QUAD-CITIES STATION

UNITS 1 AND 2

AMENDMENT 5

Commonwealth Edison Company

FIGURE 1. SUPPRESSION CHAMBER PRESSURE RESPONSE FROM FULL SCALE AND QUARTER SCALE TESTS

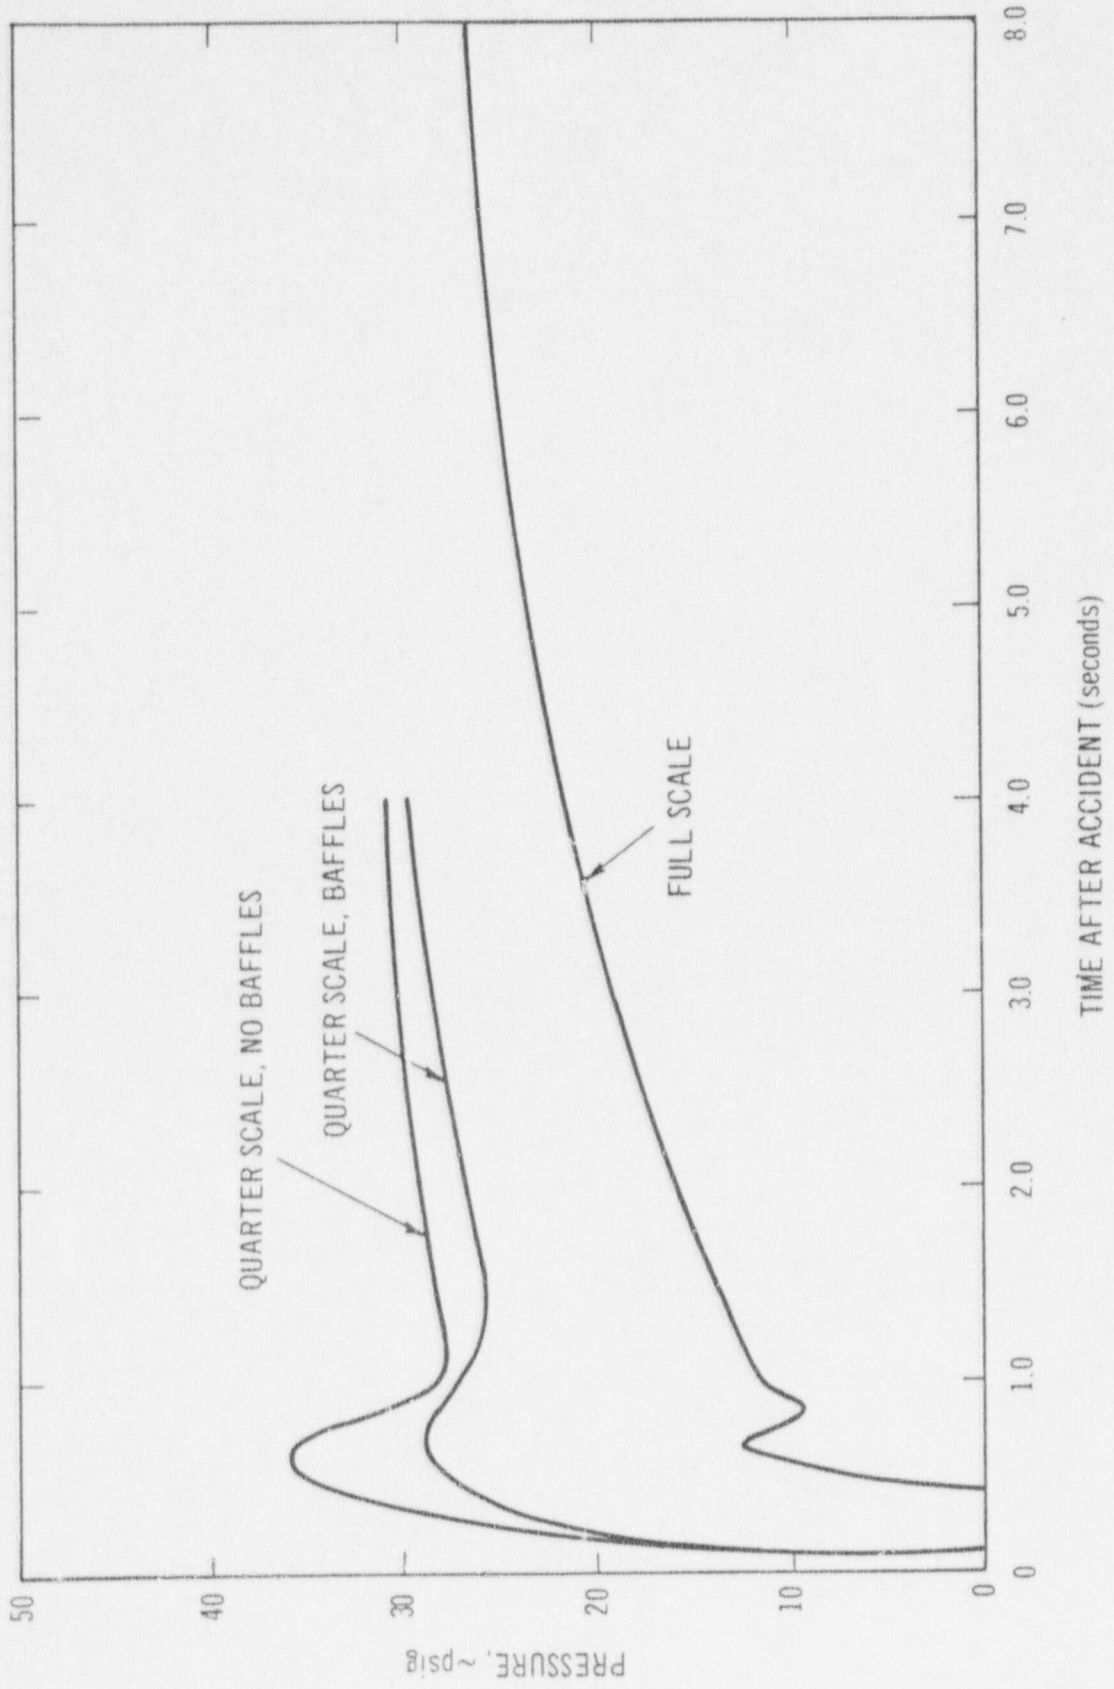
The support of Item II.2 is based on a detailed study of the test data available. In Figure 1 the measured pressure response of the suppression chamber is illustrated for the 1/4 scale tests with and without baffles and for the full scale tests which were, in essence, fully baffled. Note that with no baffles the suppression chamber pressure at about 0.7 seconds is greater than the end of transient pressure. This early overpressure was the original basis

for the baffles. Note also that at approximately the same time as the overpressure in the 1/4 scale tests, a pressure peak occurred in the full scale tests. However, in the full scale test the mean pressure was still low enough that the pressure peak did not exceed the end of transient pressure. This difference in mean pressure at the time of the peak was caused by a difference in the pressure rate in the suppression chamber. In the 1/4 scale tests, the drywell and suppression chamber volumes were reduced by 1/4. The downcomer diameter was also reduced by 1/4, which reduced the flow area per downcomer to approximately 1/16 of full scale. With fourteen downcomers the total vent flow area was approximately the same as full scale. Since the vent exit velocity was also the same for both tests, the total mass flow rate into the suppression chamber was the same. Therefore, the 1/4 smaller suppression chamber air volume was pressurized four times as fast. This results in accentuating the pressure peak for the 1/4 scale tests, since the average pressure at the time it occurred was much higher than for the full scale tests.
